RUSSELL HOTEL
EXTERNAL FAÇADE
CONDITION SURVEY
COVERING;

Report prepared by
Mark Goldman
Harrison Goldman

Report Number C5181-01
10th February 2015

4.56 **P46**

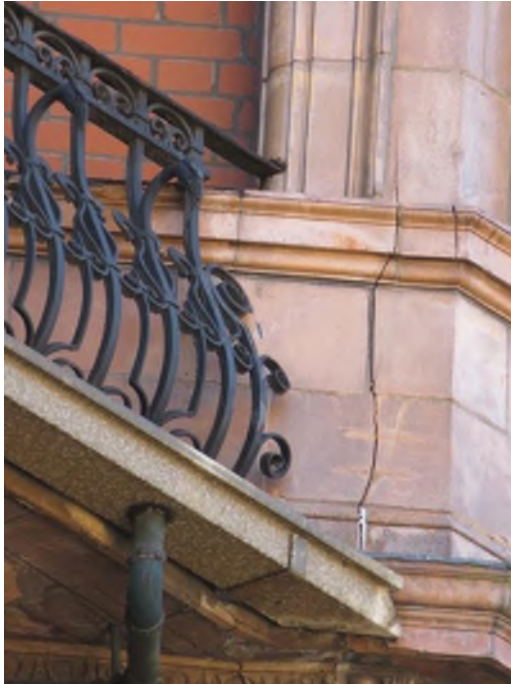
The front edge is cracked along the 1st floor balcony. This must be repaired
